## Product Change Notice (PCN)

**Subject:** Bond wire material change for RL78/F12, F13, F14 Series SSOP package products

**Publication Date:** 12/25/2024

### ■Marking specification

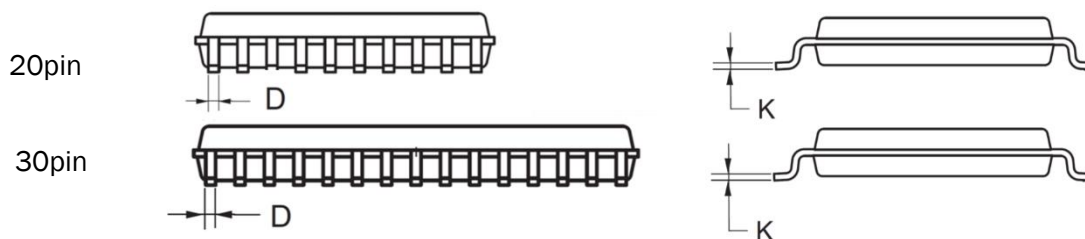
The first stage will be changed as follows.
